This Service Information bulletin supersedes SI B54 06 06 **dated November 2006**.

Water Leak from Panoramic Sunroof

Reference: SI B54 06 06

E53, E83, E61 Panoramic Sunroof Additional Sealing Procedure

Picture 1 / Bild1

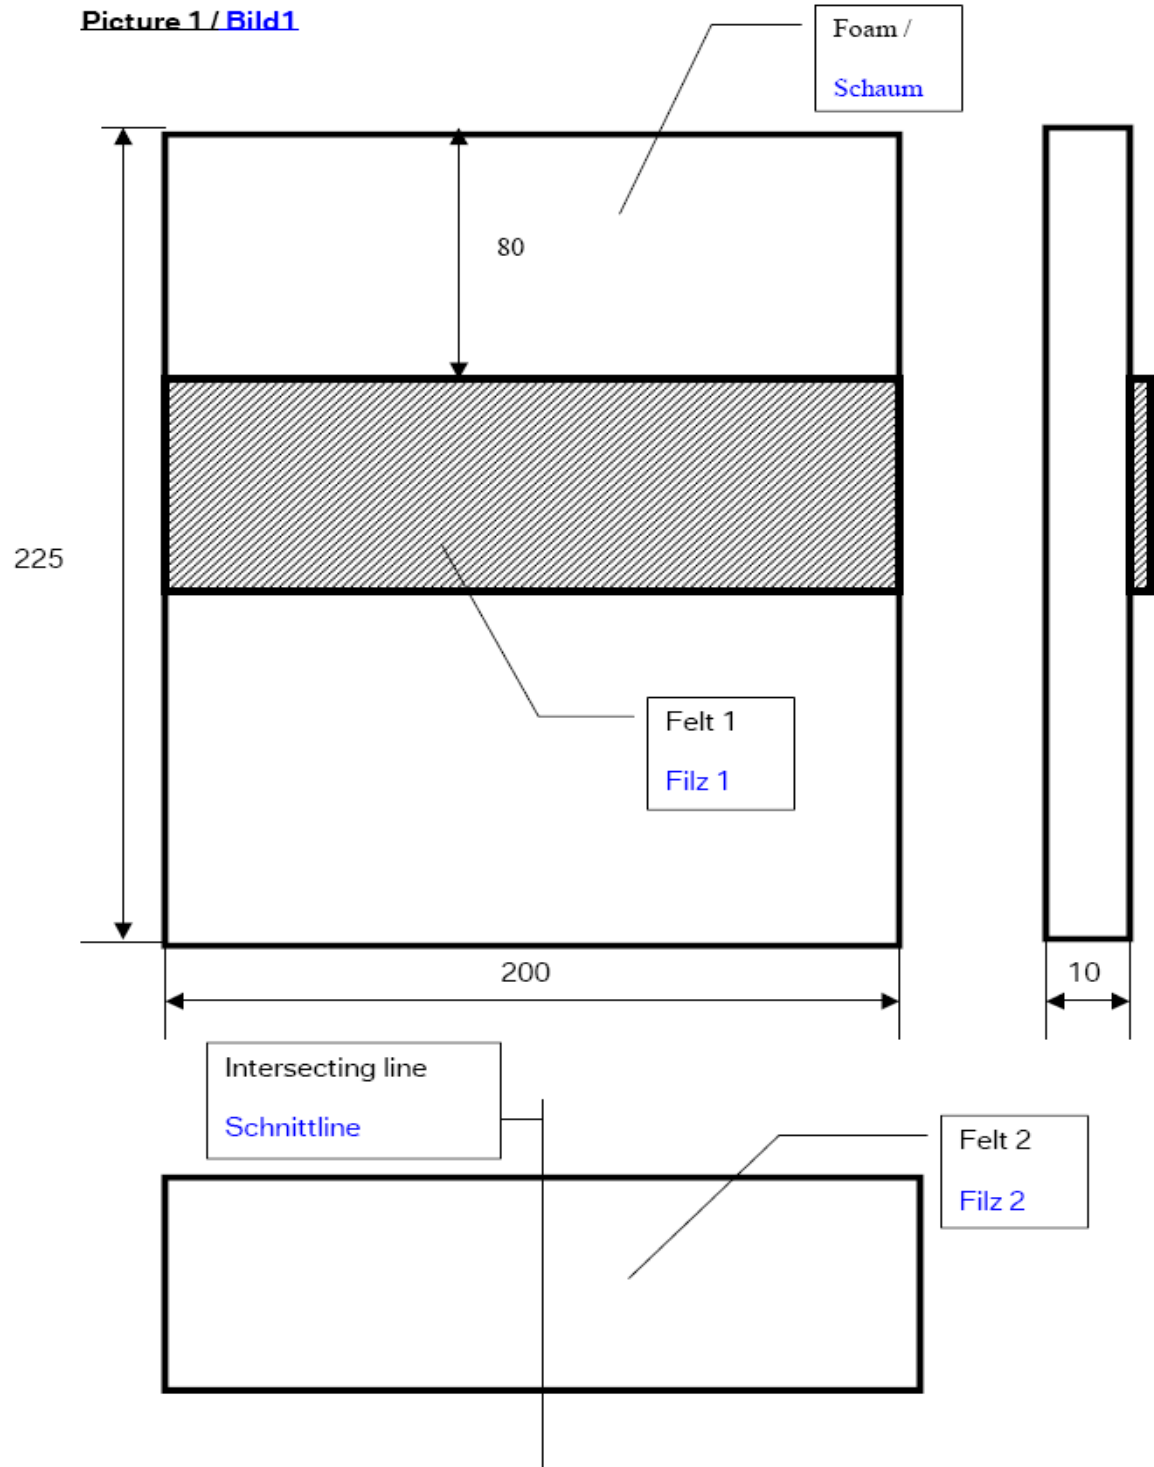
1. Cut foam as seen in Picture 1 to the dimension 225mm X 200mm.
2. Glue Felt 1 on foam as seen in Picture 1 and Picture 2.
3. Cut Felt 2 in the middle as seen in Picture 1.
4. Remove switch console from Headliner (Picture 3).
5. Glue one part of divided Felt 2 to the headliner on the right side as seen in Picture 4.
6. Glue the other part of divided Felt 2 to the headliner on the left side as seen in Picture 5.
7. Fit prepared foam assembly as shown in Picture 6 and Picture 7.
8. Install switch console.

Sealing Side Seams

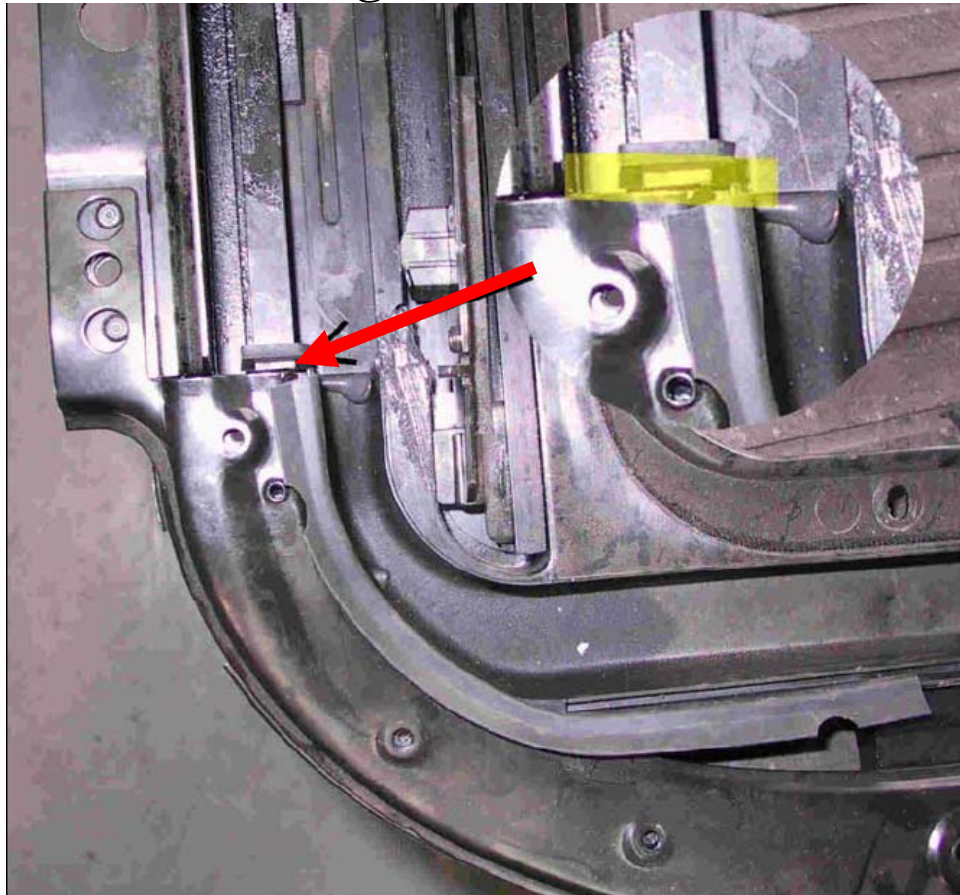
- Water may leak from the seam shown; where the side rail of the cassette meets the front section.
- Apply a bead of sealant, such as Sika-flex, along the complete length of the joint.
- This procedure should be performed for both the right and left side of the cassette.
